Your Ref	SSD-34919690-Mod-2
Our Ref	NCA/3/2022
Contact	Douglas Bennett
Telephone	02 9806 5405
Email	dbennett@cityofparramatta.nsw.gov.au

**COUNCIL SUBMISSION TO REQUEST FOR ADVICE ON MODIFICATION REPORT –
NOVUS ON HARRIS AT 39-43 HASSALL STREET, PARRAMATTA**

Figure 3 – Indicative location of trees

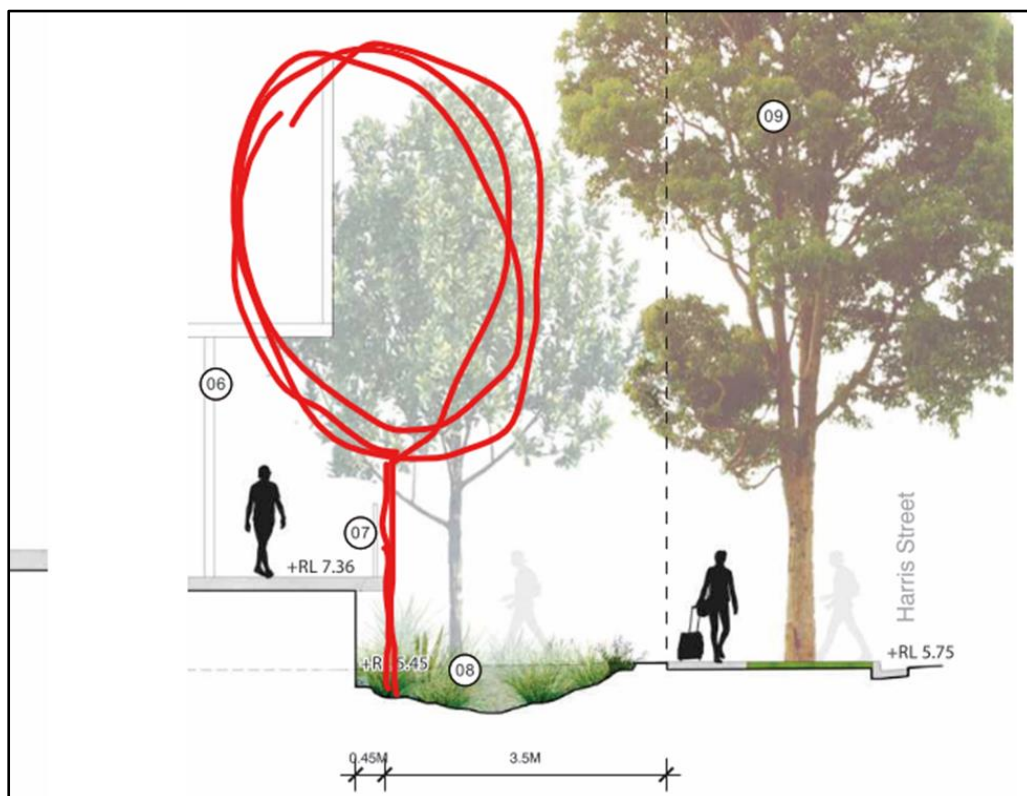
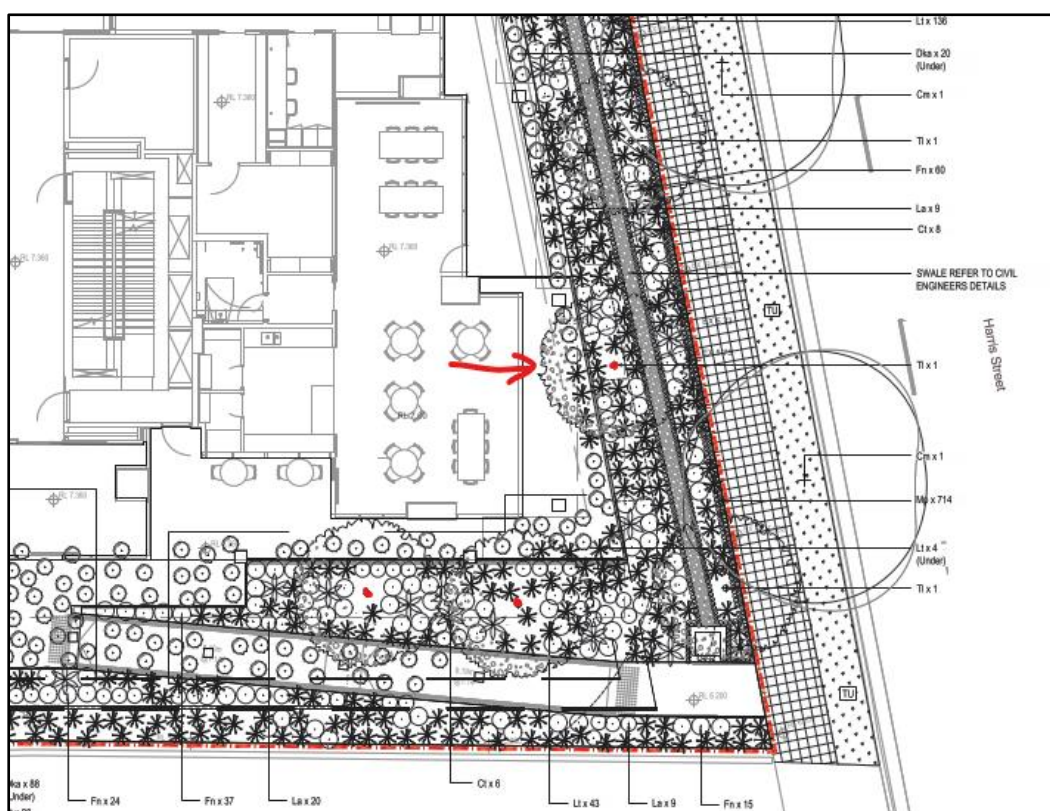
Council has reviewed the revised landscape report for the modification application and raises concern over the location of 4 x *Tristaniopsis laurina* (Watergum) trees, at ground level, that are shown to only be planted between 0.45-0.5m away from the approved building. This is not considered to be ideal. The proximity to the building means the trees will clash with the building façade, causing on-going building maintenance issues. Constant pruning will be required, resulting in the poor form, structure and overall decline of the proposed trees. The likely outcome of this will be the eventual removal of the trees from the site.

Section B of the application's accompanying landscape report incorrectly illustrates the location of *Tristaniopsis laurina* and shows the tree as clashing with the building façade (see figures below).

- All trees at ground level are to be relocated a minimum 3m away from the edge of the building. Detail is to be provided in an amended report.
